ADDENDUM NO. 4

To: Invited Bidders
Project: **St. Mary Fort Walton Beach Admin Building & Renovation**
Fort Walton Beach, Florida
Date: June 24, 2026 Bid Date: June 30, 2026
Architect: Quina Grundhoefer Architects

1
A2.1 South Elevation
3/16"=1'-0"

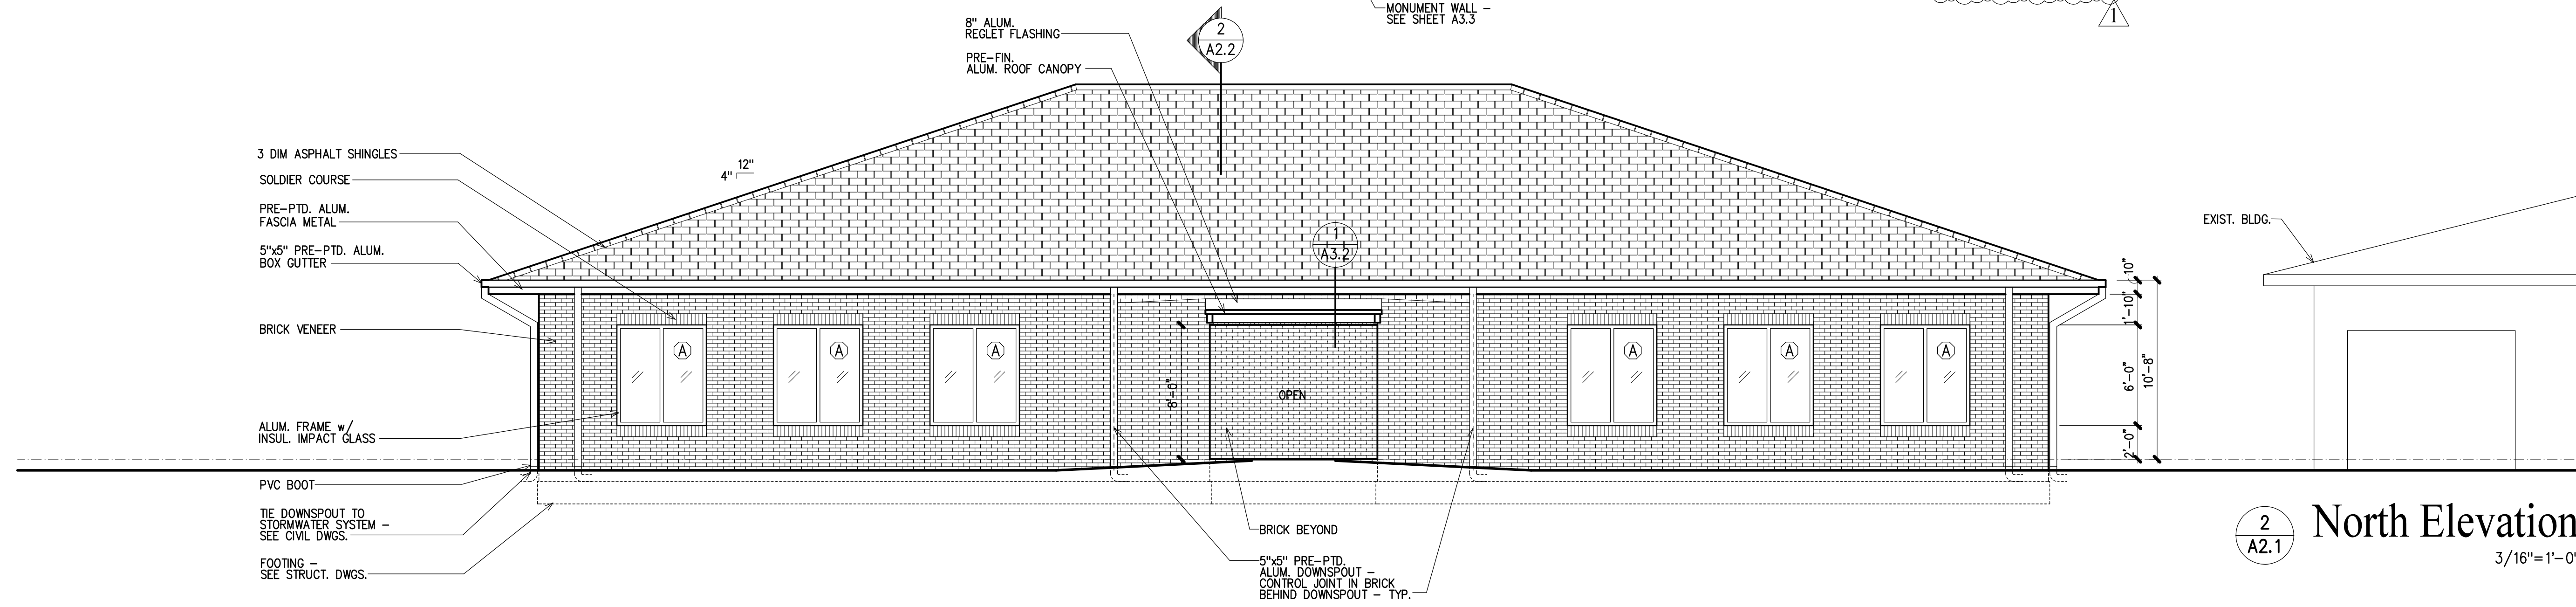
- a. Add Knox box above truss signage near front entry on 1/A2.1 South Elevation.

Door Elevations
3/8"=1'-0"

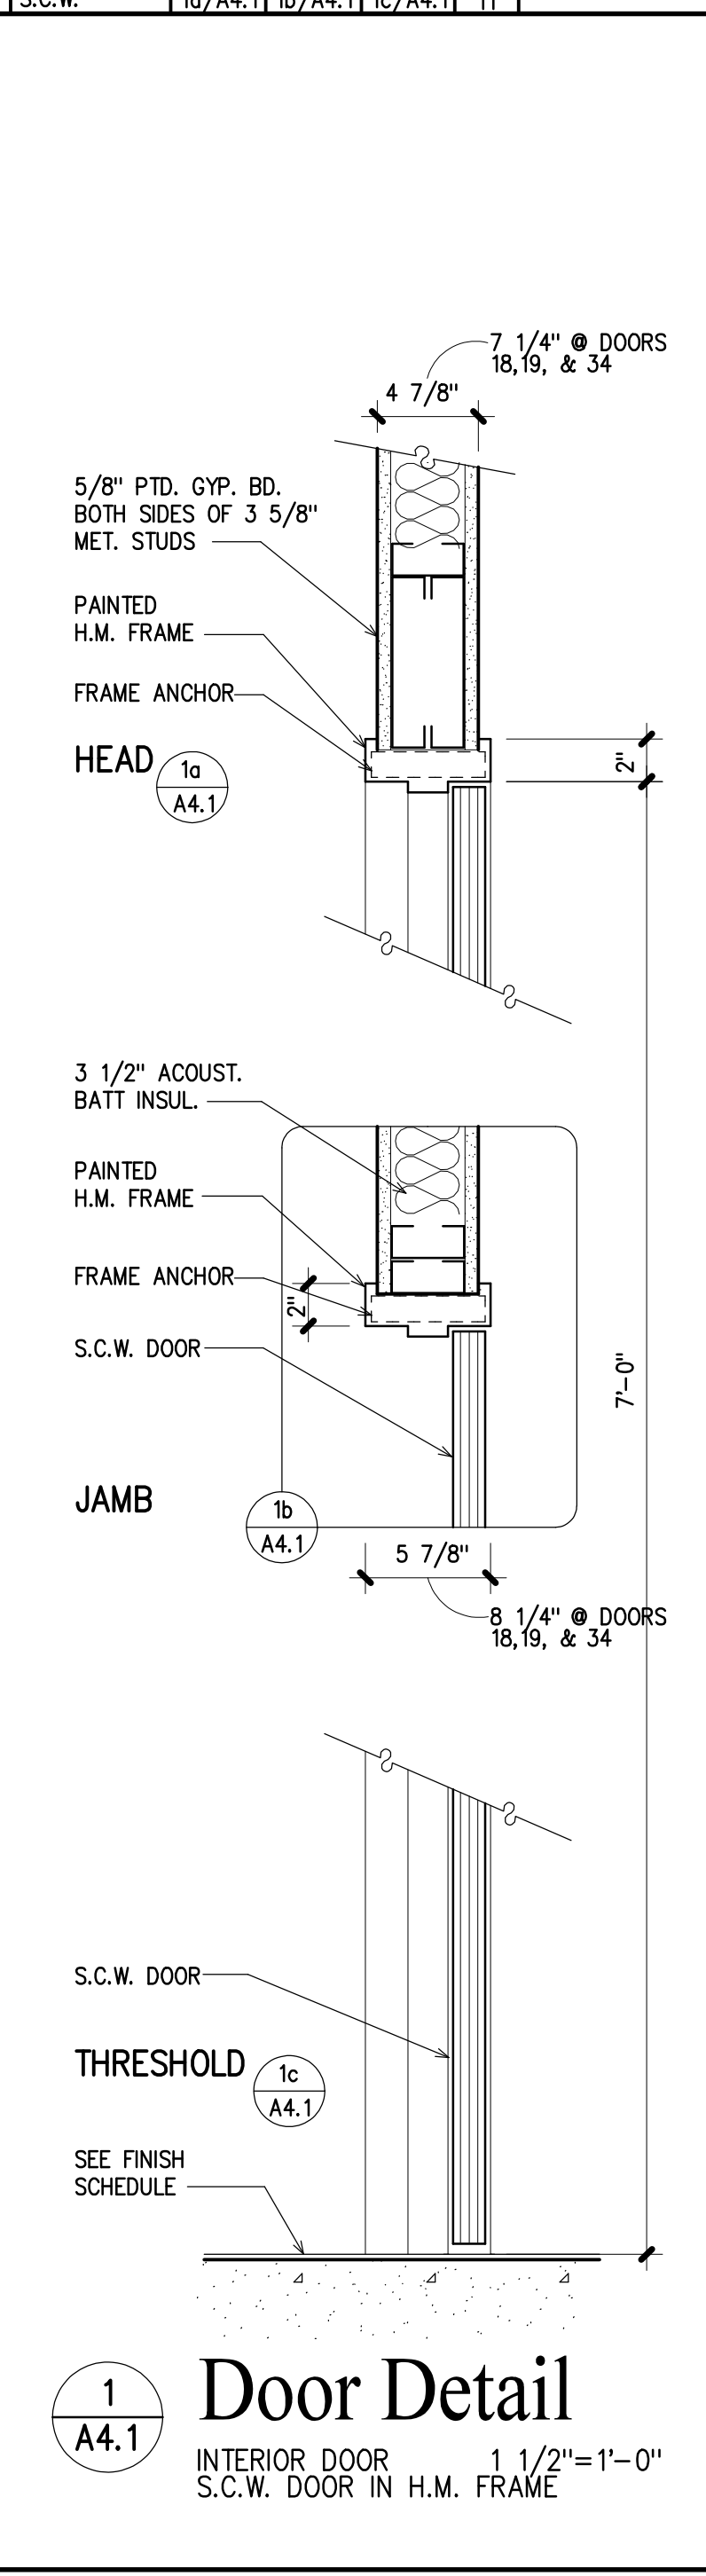
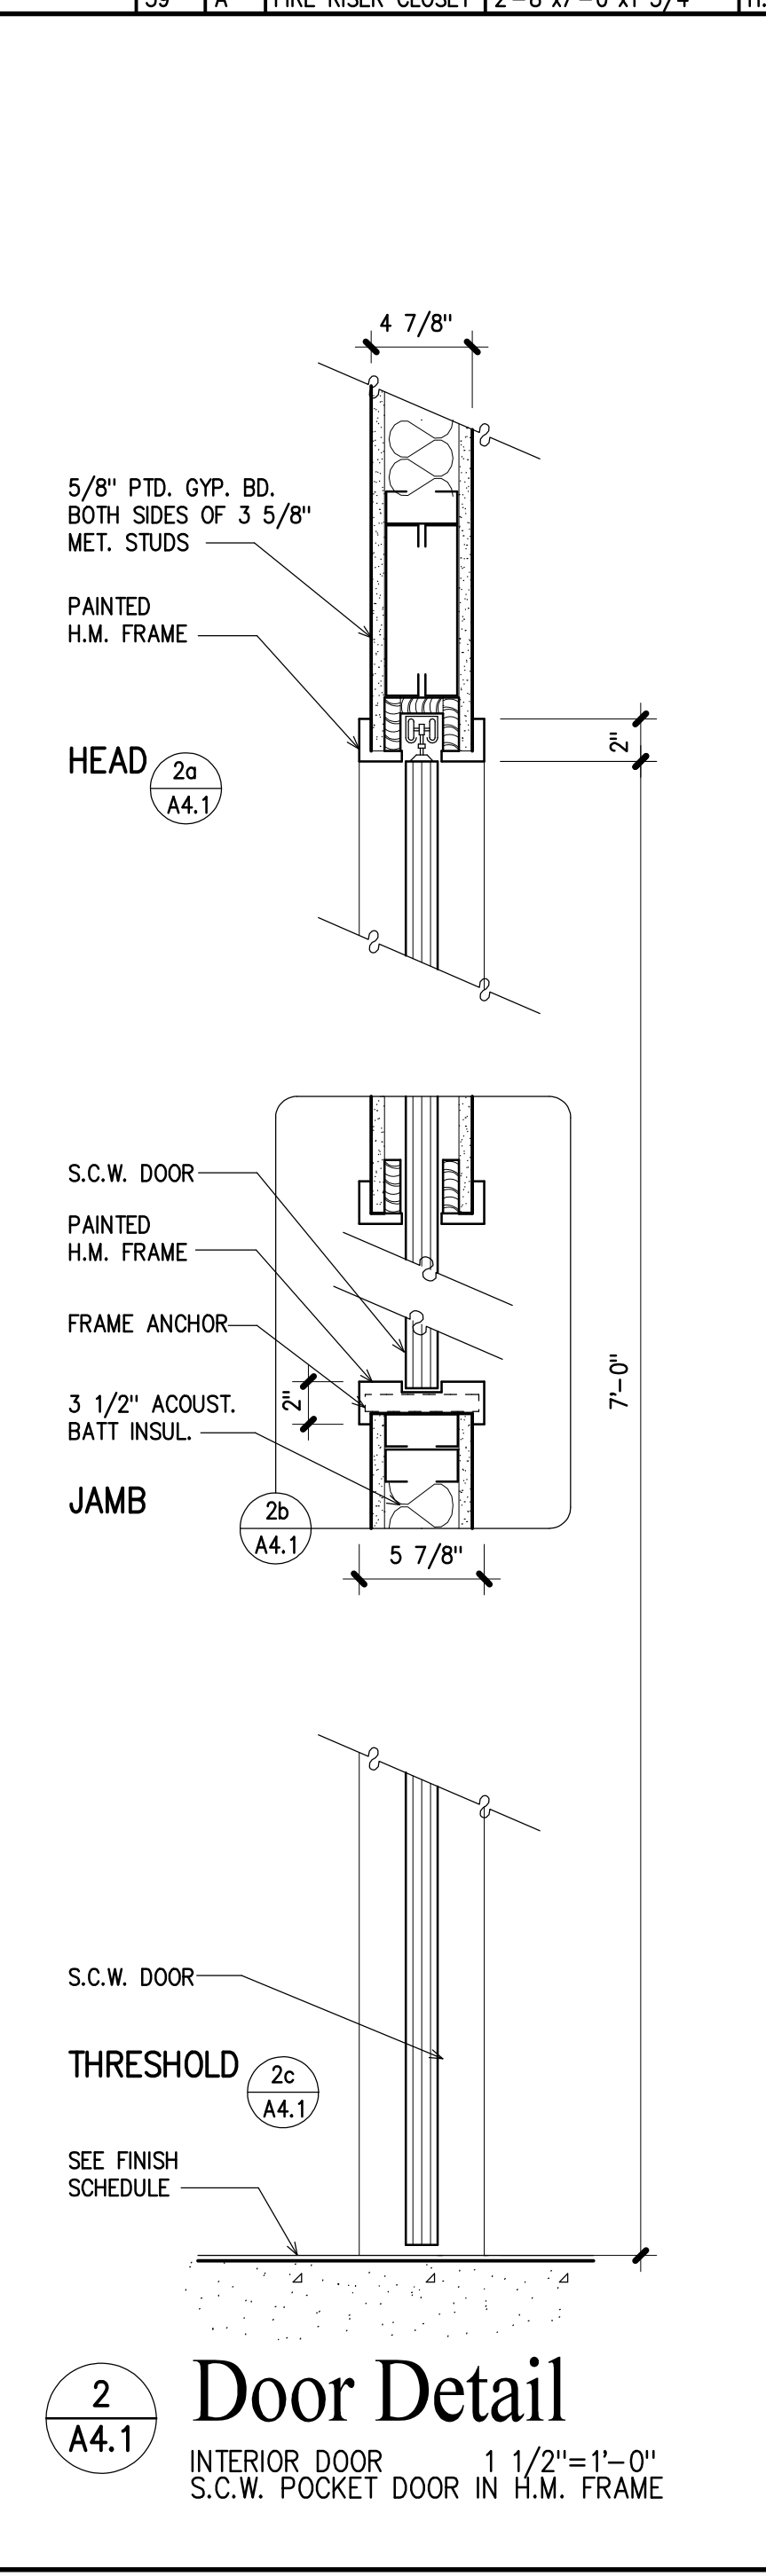
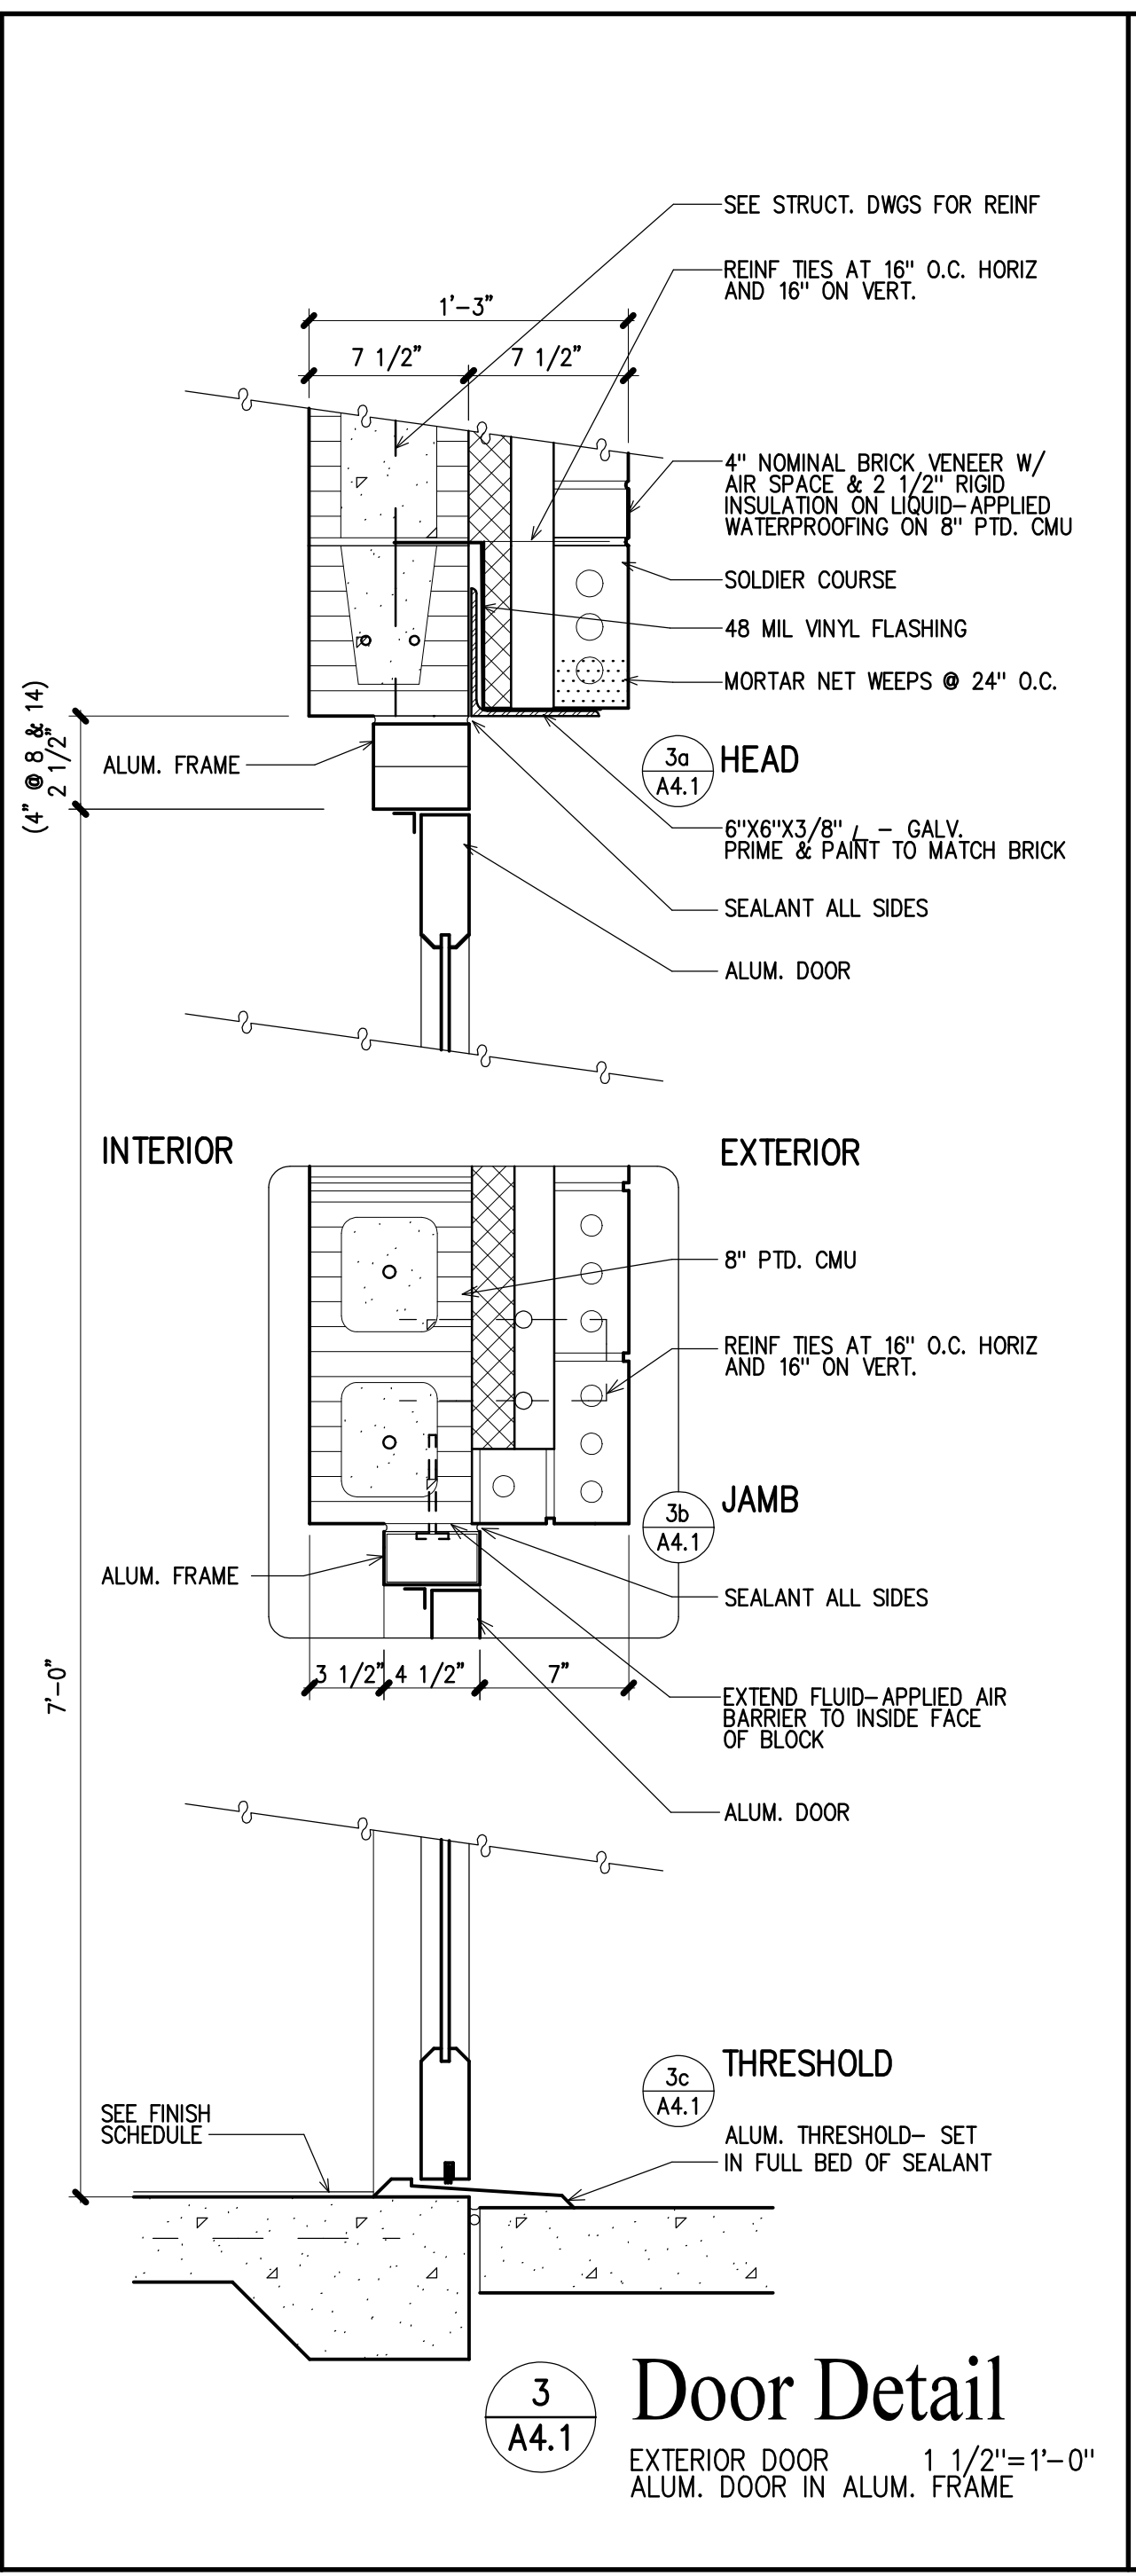
- a. Add door elevation H to sheet A4.1.
- b. Change doors 17 & 27 from elevation B to H.
